ADDENDUM No. 1

REQUEST FOR QUOTATIONS No.: 1220-040-2022-020

TITLE: Coverdale Fairgrounds Shannon Hall Boiler Replacement

ADDENDUM ISSUE DATE: February 15, 2022

1.1 Drawing No.: M0.01 – Cover Page

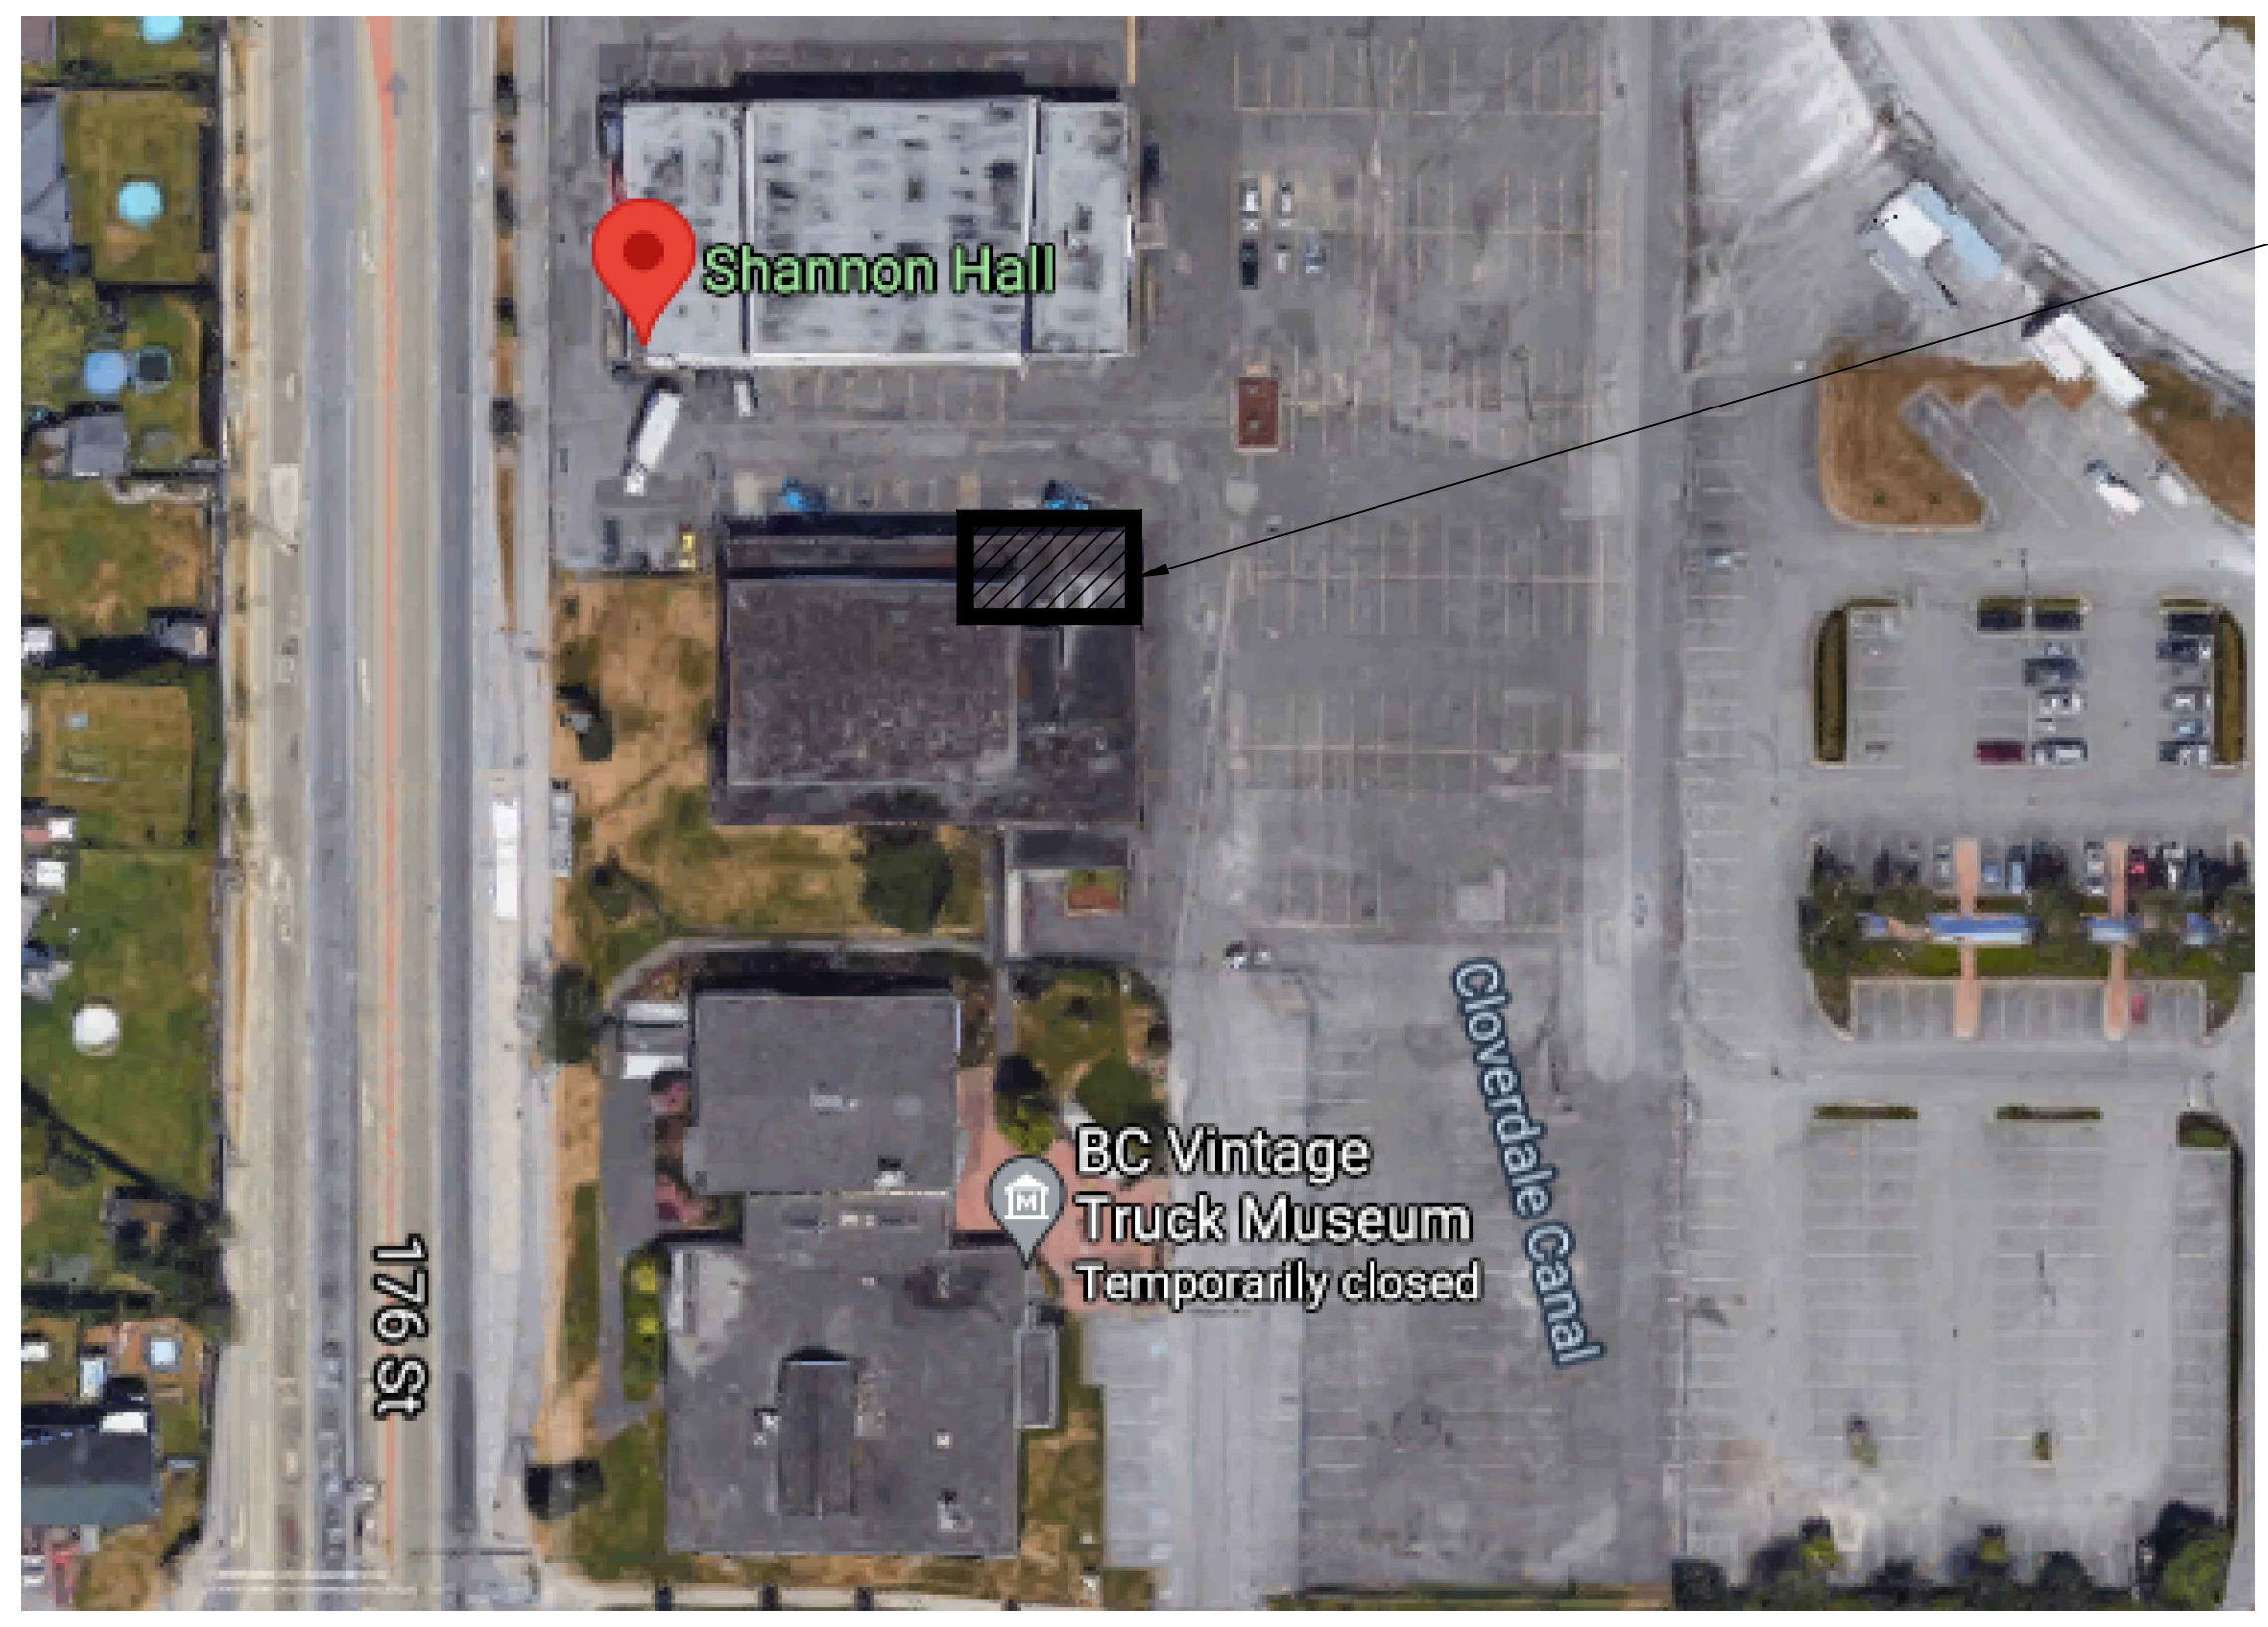
- .1 Add:
 - .1 Air Separator Schedule added; refer to drawings for details.
 - .2 Pump Schedule added; refer to drawings for details.
- .2 Delete:
 - .1 Variable Frequency Drive (VFD) Schedule deleted.
- .3 Revise:
 - .1 Motorlist Schedule: Pumps P-1,2 updated and moved from existing equipment to new. Refer to drawings for details.

2 MECHANICAL RENOVATION SCHEMATIC
SCALE: NTS

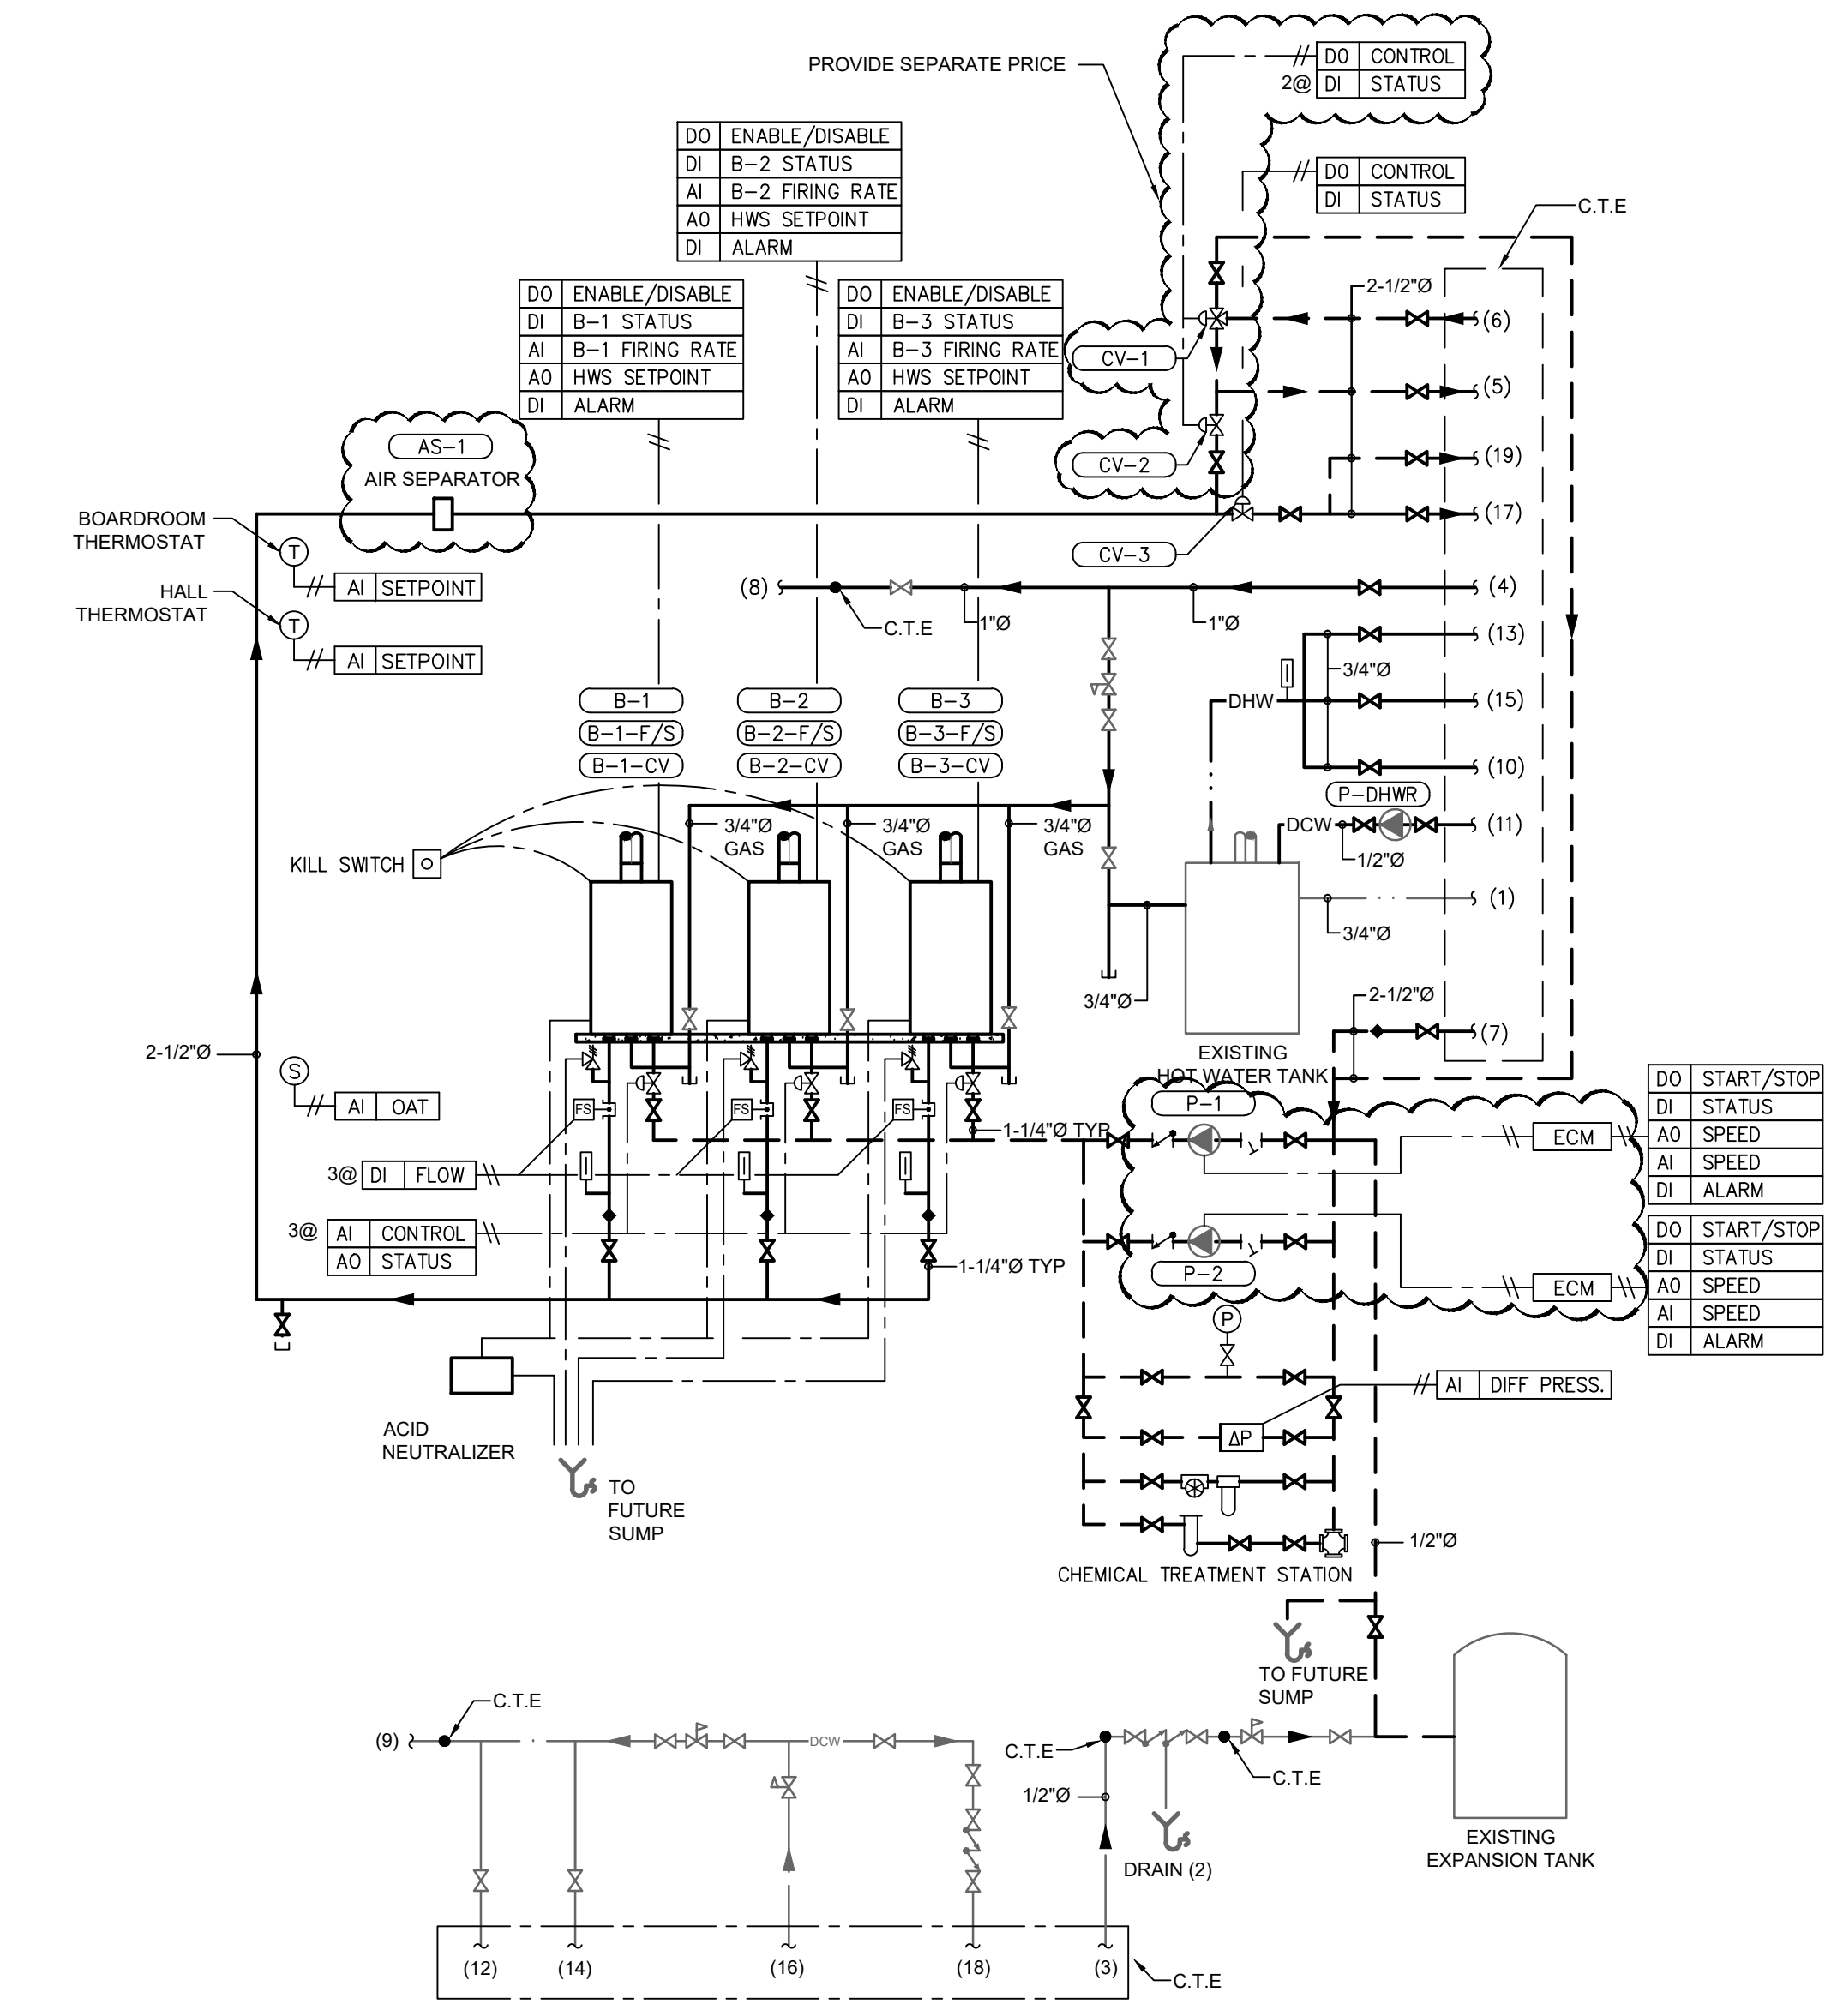
Q4. Ref. Pricing notes: M0.01 "Separate Pricing for Cascading operations". Can the scope be more defined with bill of materials?

- .1 Add:
 - .1 Tag AS-1 for Air Separator added to 2/M1.01
- .2 Delete:
 - .1 Note: “Existing Pumps” from P-1,2 deleted from 2/M1.01.
 - .2 Tags V-1,2 on VSD deleted from 1/M1.03 and 2/M1.03
- .3 Revise:
 - .1 “VSD” on circulation pumps P-1,2 changed to “ECM”

A4. The components included in the clouded area in detail #2 of drawing M1.01 [Mechanical Renovation Schematic] represents the scope for cascading operations.
